## REVISED RESPONSE TO REQUEST FOR ADDITIONAL INFORMATION

### APR1400 Design Certification

Docket No. 52-046

RAI No.: 171-8143  
SRP Section: 11.03 – Gaseous Waste Management System  
Application Section: 11.03 – Gaseous Waste Management System  
Date of RAI Issue: 08/25/2015

Figure 1. Schematic Diagram of GWMS

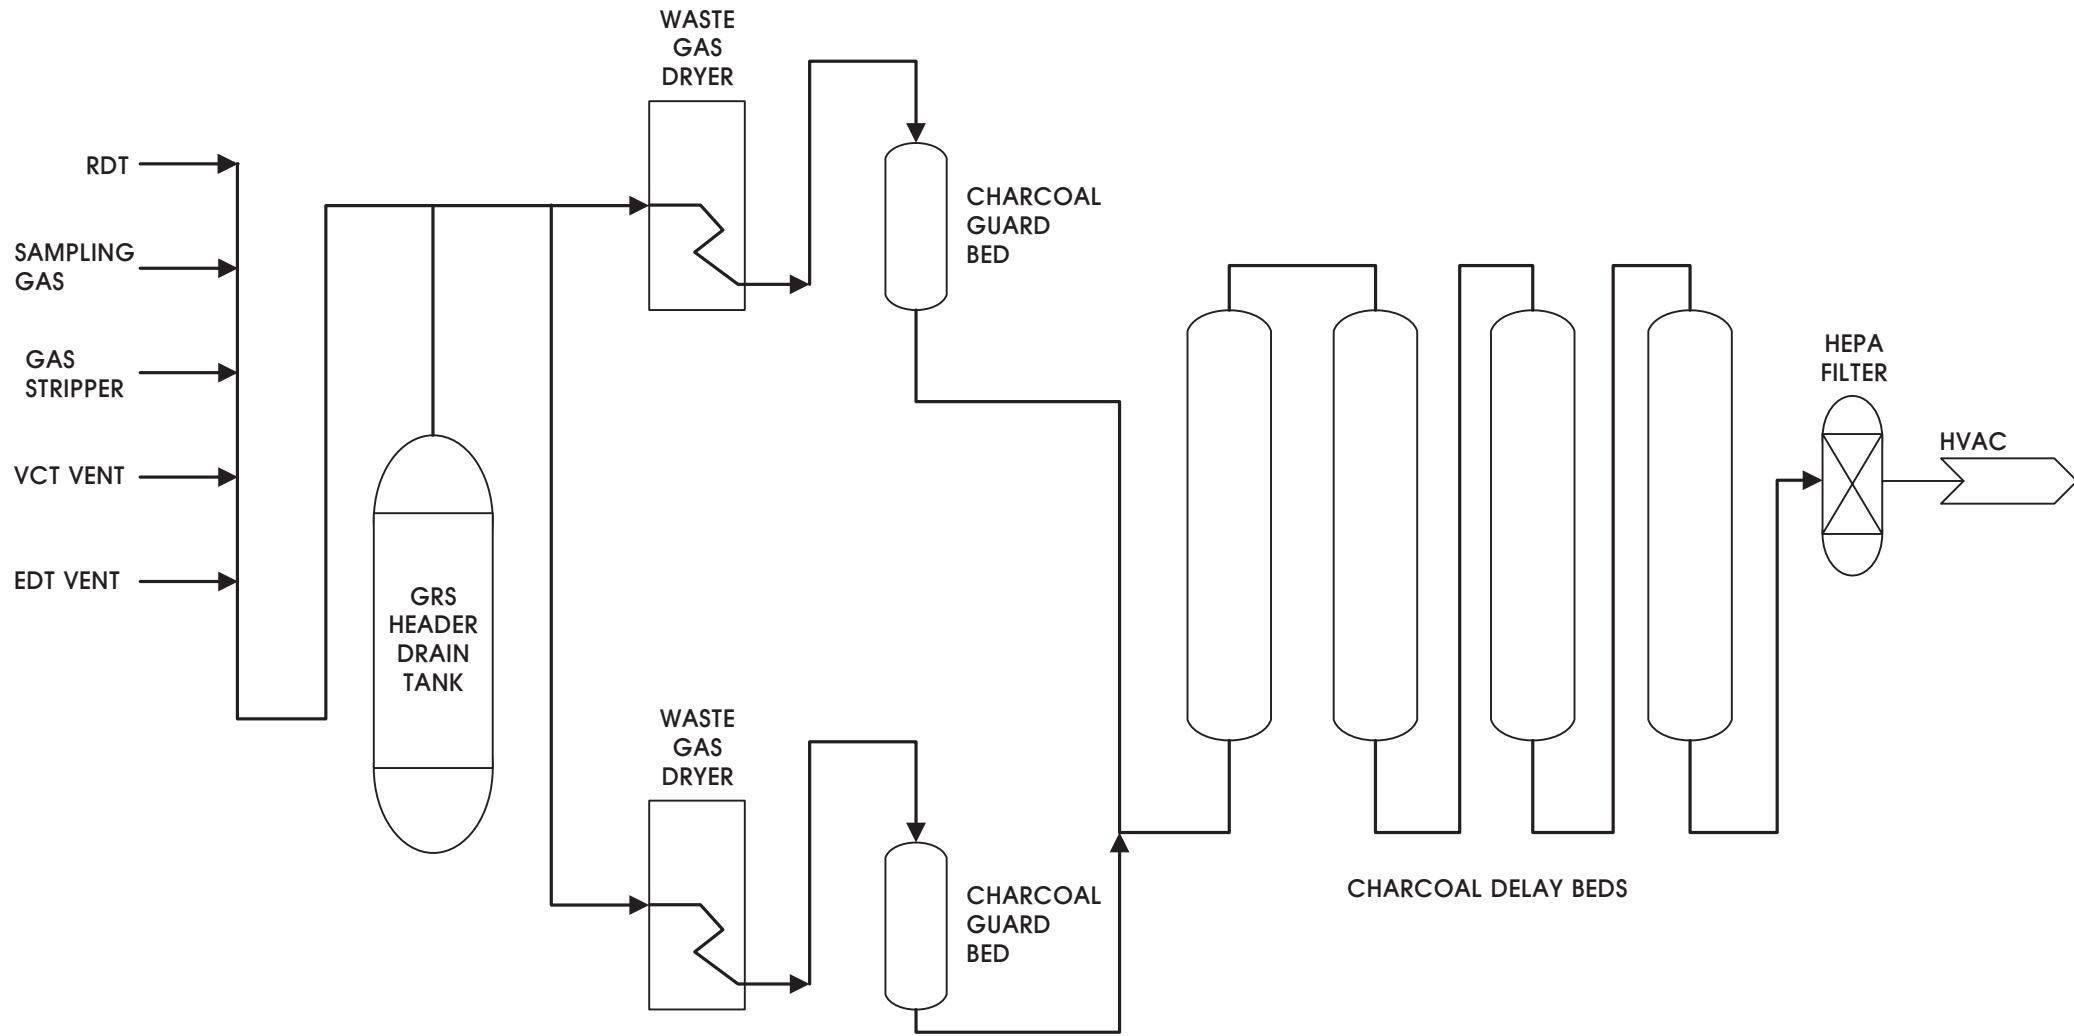
The staff reviewed DCD section 11.3.3.2 and Table 11.3-9 that show the applicants Gaseous Waste Management System Failure Doses. These doses appear to be in within BTP 11-5 guidelines, however the staff requests a calculation package to verify the results provided in Table 11.3-9, specifically:.

1. BTP 11-5 describes the use of Regulatory Guide 1.109's Table B-1 for use in calculating the results of the BTP 11-5 analysis. Please verify the use of these values in Table B-1.
2. Results of NRC staff review of an equation on page 11.3-27 suggests that KHNP used FGR 12, applying the RADTRAD Computer Code, as the source for dose conversion factors. Please verify the source of the dose conversion factors.

3. The calculation package should include a description of all parameters used in the analysis to determine the results of Table 11.3-9. Please provide a detailed list of all parameters utilized to determine Table 11.3-9 results.
4. The calculation package should include a list all equations used to calculate the results of Table 11.3-9. Please provide all equations utilized for Table 11.3-9 calculations.
5. Please provide an equation or DCD reference section for all parameters found on page 11.3-27.
6. Please provide clarification to section 11.3.3.2 to describe the source of data for parameters R(i)n, R(i)a, and MF(i) and also provide the equations used to calculate the discussed variables.

Please address the items above and provide a mark-up on the proposed DCD changes.

The source term data provided in Table 2 are different from those used in calculating the dose values in DCD Table 11.3-9. KHNP revised the source term data to only include the release from GWMS. Therefore, DCD Table 11.3-9 will be updated to incorporate this change of the source term. Previous calculation used the total source terms from PWR-GALE Code output which is the sum of the GWMS release and the building ventilation releases. However, since this analysis only needs to consider release from the failure of waste gas system, the releases from other vents are not required to be included.

The schematic diagram of APR1400 GWMS is provided in Attachment 2 of the response.
